## 8A Miscellaneous Electrical Systems

The information in this appendix of the reference ABWR DCD, including all Subsections and figures, is incorporated by reference with the following departures and supplements.

**Figure 8A-1 Site Plan (Grounding)**

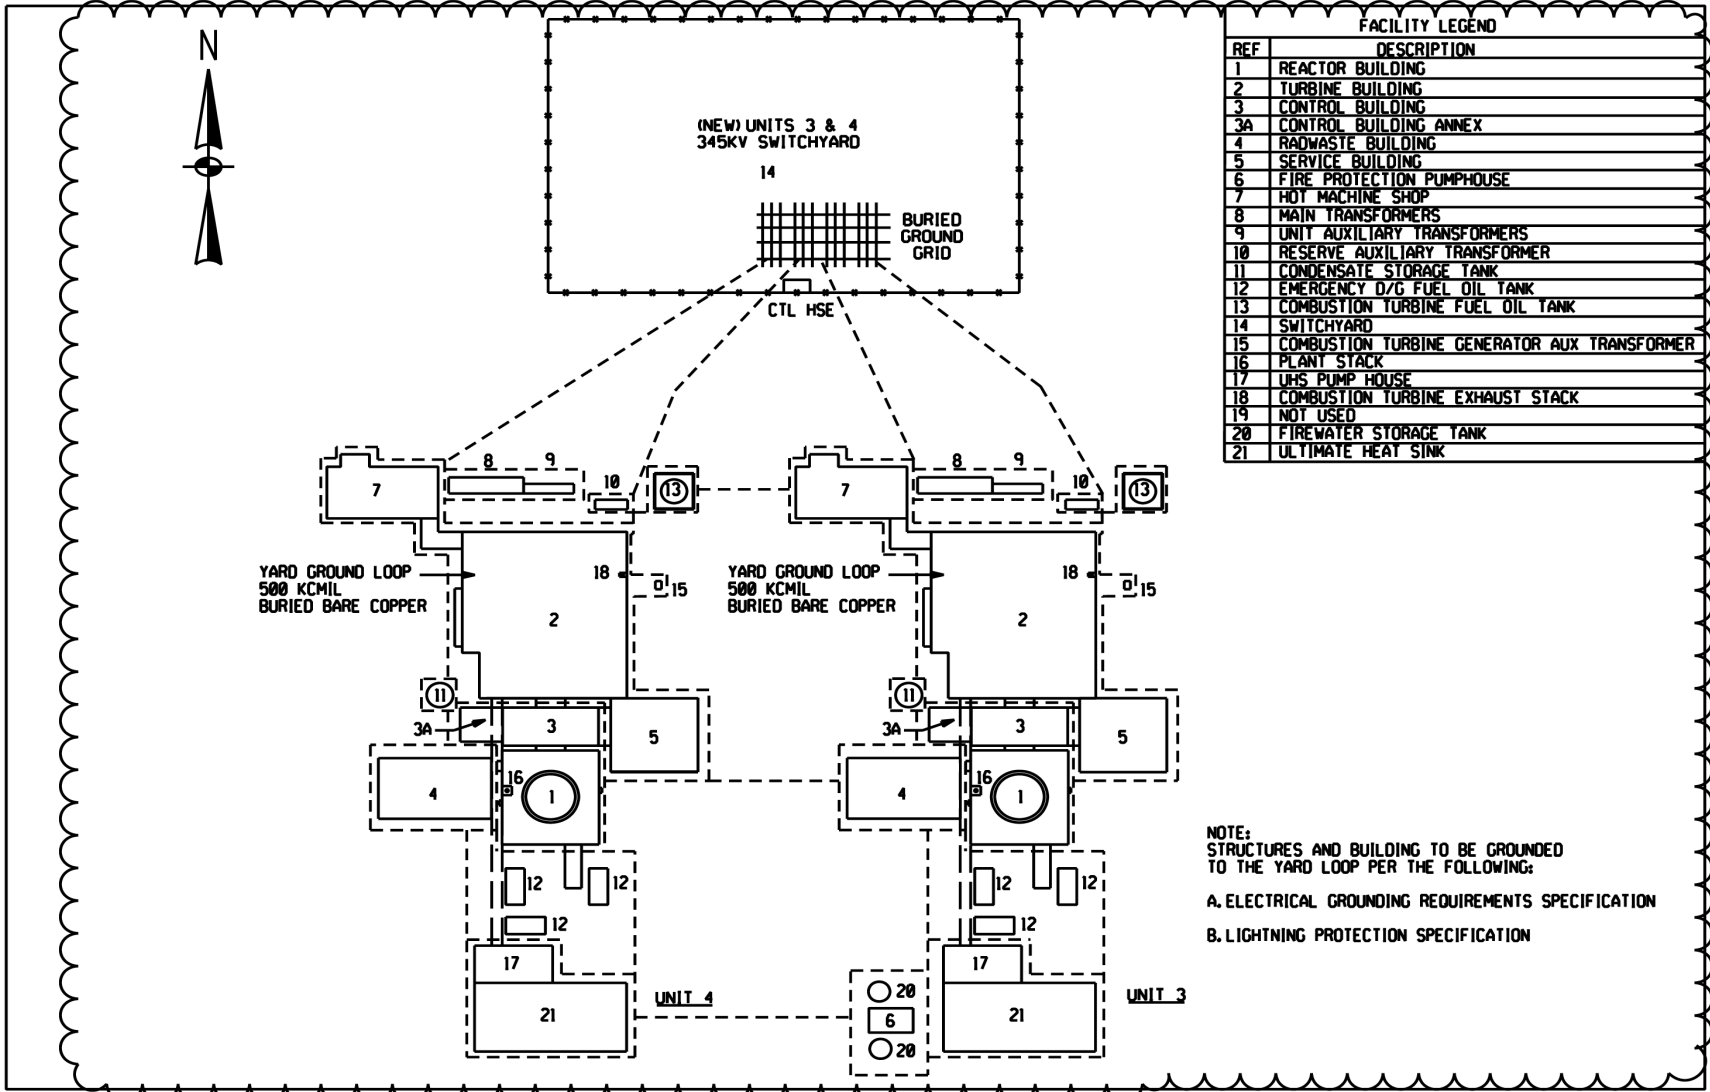
STP DEP 1.1-2 (Figure 8A-1)
